Three Mile Island Nuclear Station, Unit 2 (TMI-2)  
Operating License No. DPR-73  
Docket No. 50-320  
Nuclear Instrumentation

NRC letter NRC/TMI-88-008 dated March 9, 1988, transmitted three (3) comments in response to GPU Nuclear letter 4410-88-L-0009 dated February 10, 1988. The referenced GPU Nuclear letter proposed to use an alternate nuclear instrumentation system in the event that the installed nuclear instruments, specified in the current Technical Specifications, are rendered inoperable during planned plasma arc torch operations in the Reactor Vessel. The attachment provides a response to each NRC comment.

The following block diagram illustrates the equipment that is being used for the alternate NI strings:

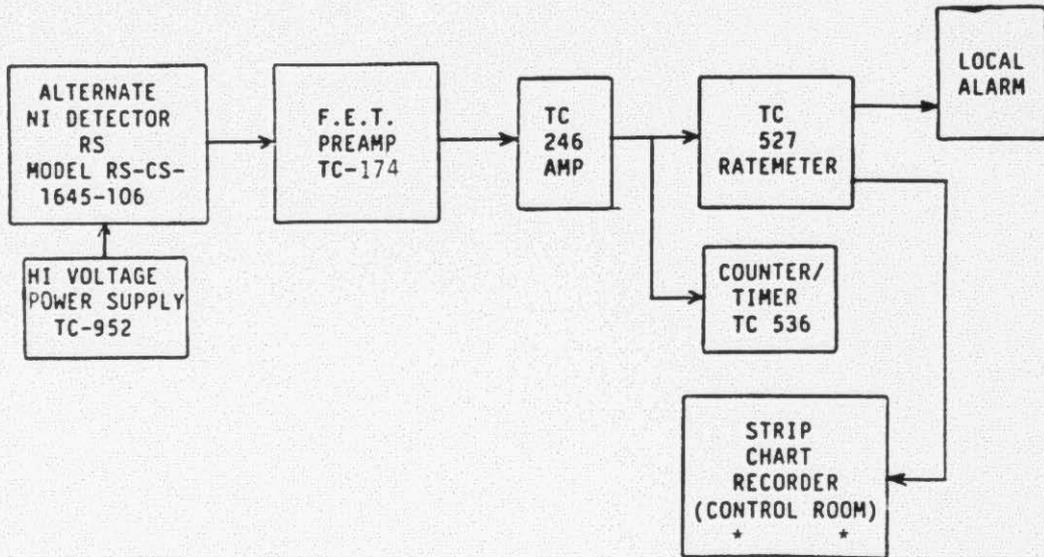
Provide a more detailed description of the alternate NI system including the sensitivity, range, reliability, and alarm capability.

The TC 527 ratemeter is a stable, highly accurate device with simultaneous logarithmic and linear displays. Two scales are provided with the following ranges:

The readout module also contains a built-in calibrator and a local audio alarm function with an adjustable threshold and variable tone for indication of count rate. Additionally, a remote strip chart recorder will be connected to the ratemeter and located in the Control Room. Alarm indication will also be provided in the Control Room to provide timely response to changes in the reactivity of the core. The detector and readout strings are connected via a General Electric radio frequency coaxial low capacitance cable to minimize noise induction.
